# WESTGROVE RETAIL MCKINNEY

## EXTERIOR FINISHING MATERIALS

WHOLE FOODS RETAIL PLAZA EXTERIOR ELEVATIONS

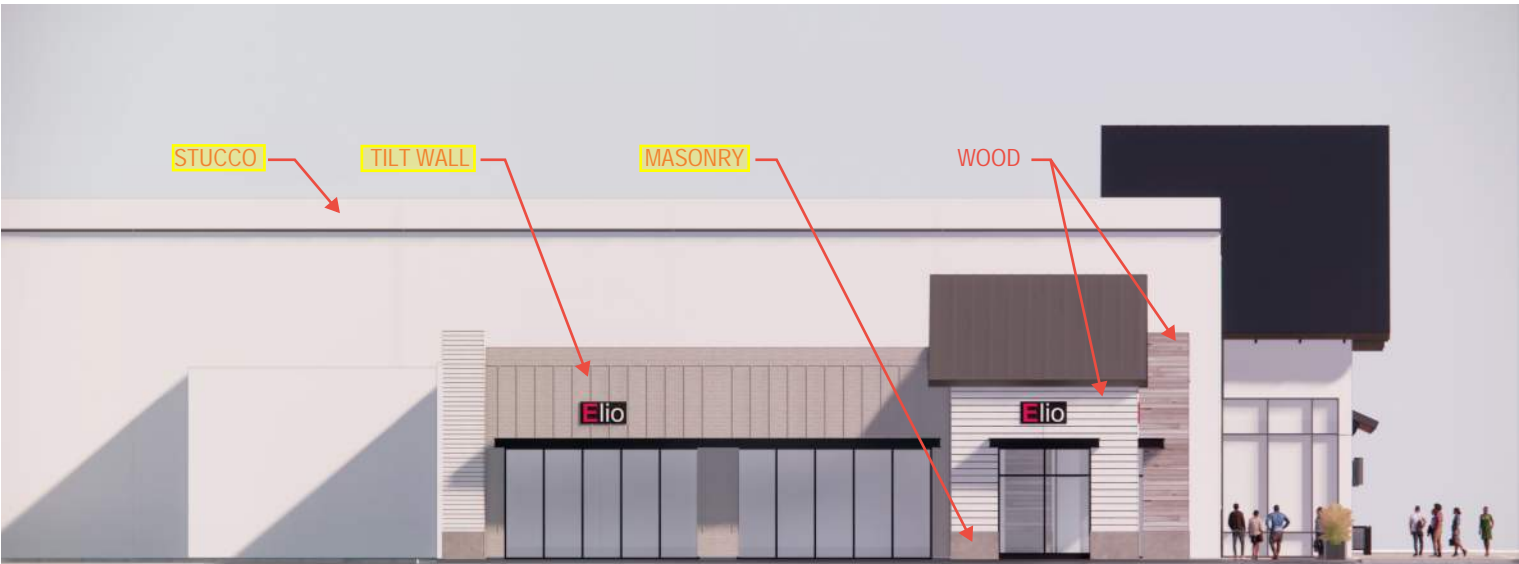
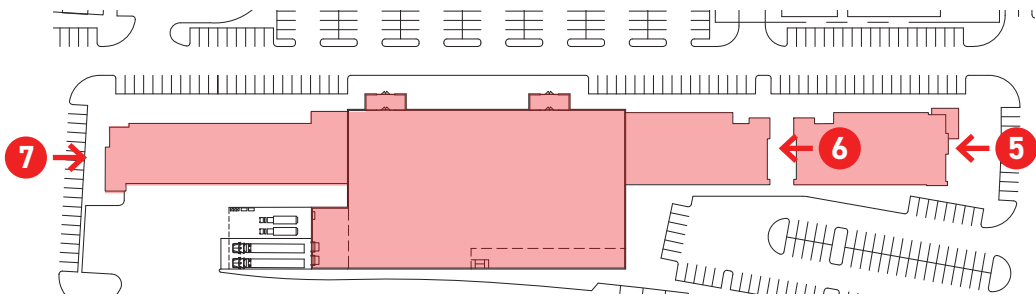
50% masonry finishing material required on all elevations.

Detail needed for required two offsets, at least 18in in depth, on elevations 50ft or greater in length.

Information not yet provided for the protected primary entry feature. Coverings shall be no smaller than three feet in depth.

Information not yet provided from the additional feature options in Section 146-139(f)(9)(f)(6).

WHOLE FOODS RETAIL PLAZA EXTERIOR ELEVATIONS

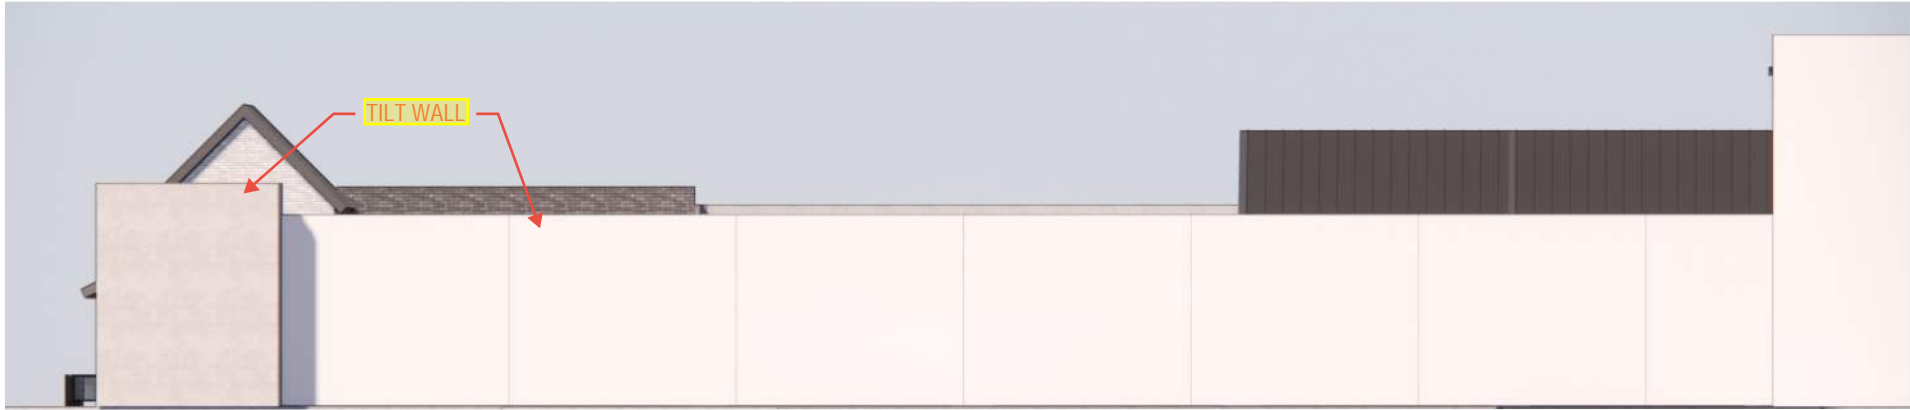
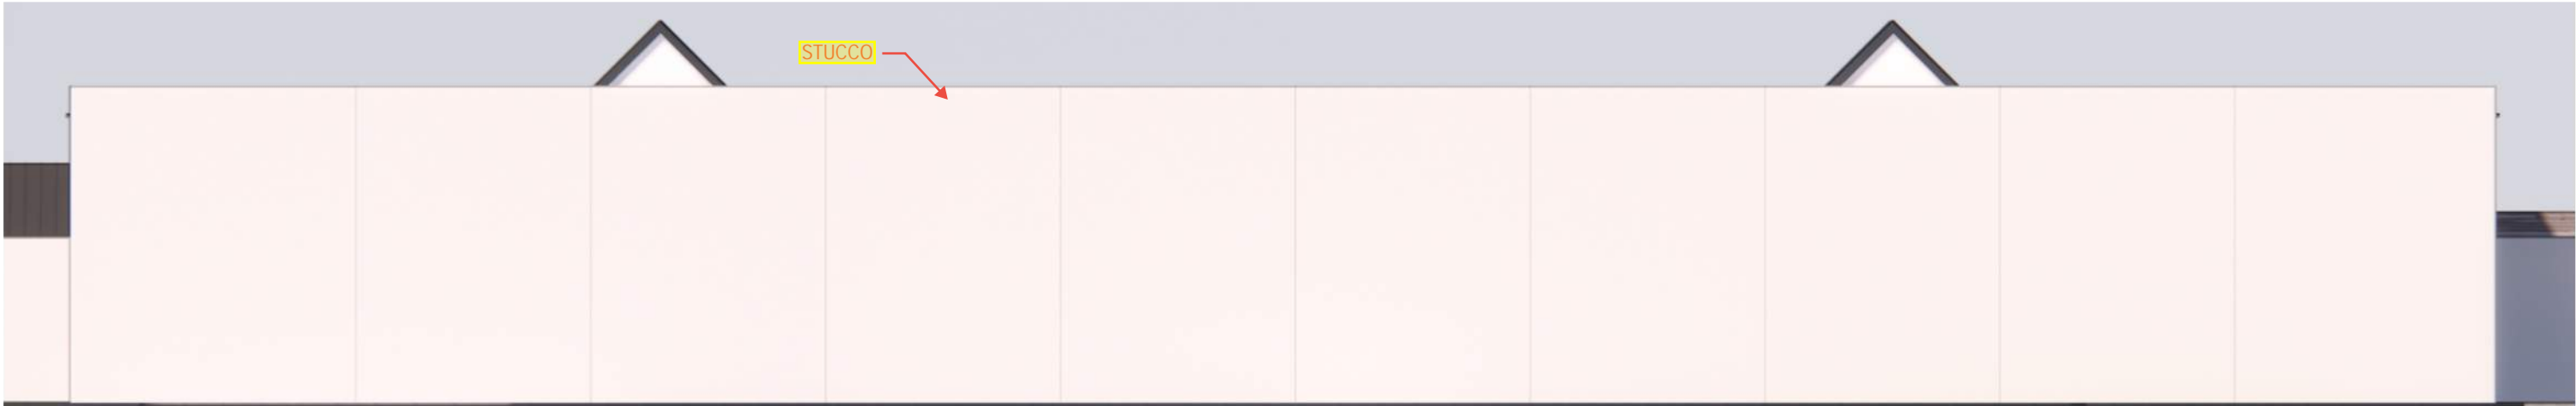
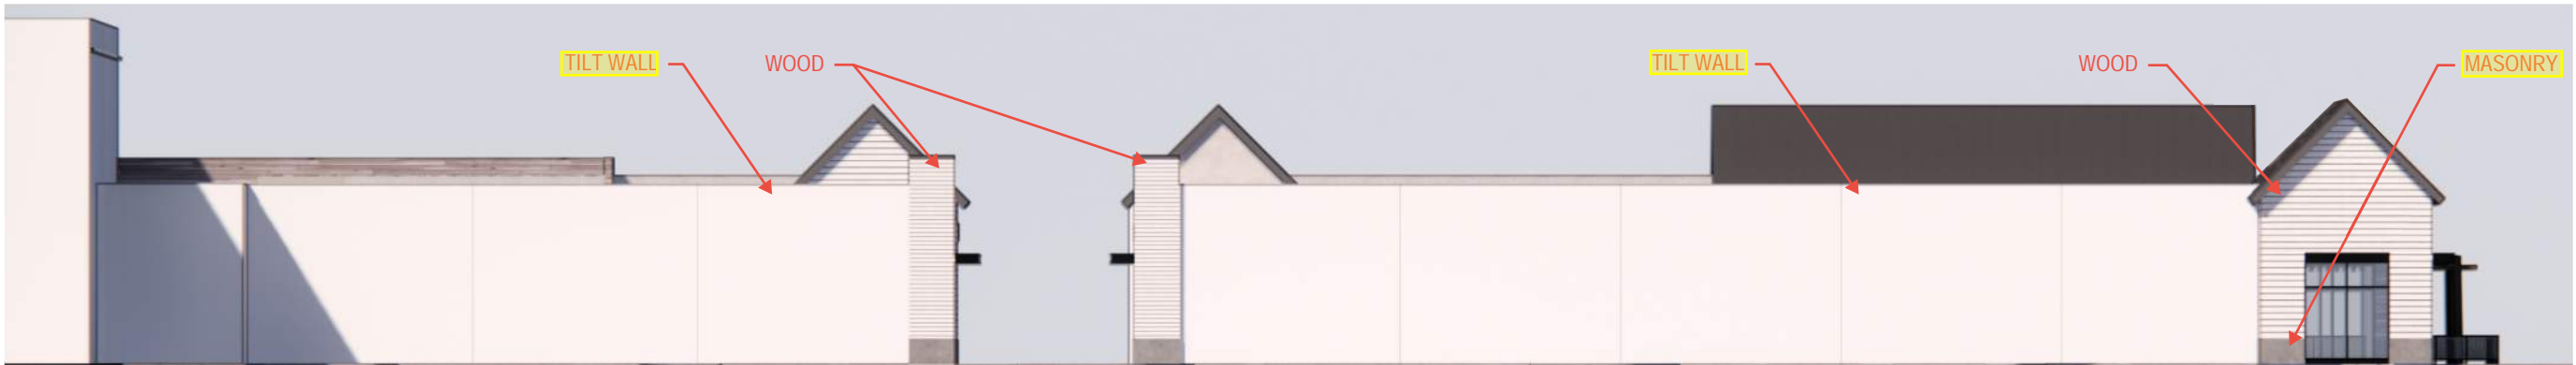
Detail needed for required two offsets, at least 18in in depth, on elevations 50ft or greater in length.

Information not yet provided for the protected primary entry feature. Coverings shall be no smaller than three feet in depth.

Information not yet provided from the additional feature options in Section 146-139(f)(9)(f)(6).

50% masonry finishing material required on all elevations.
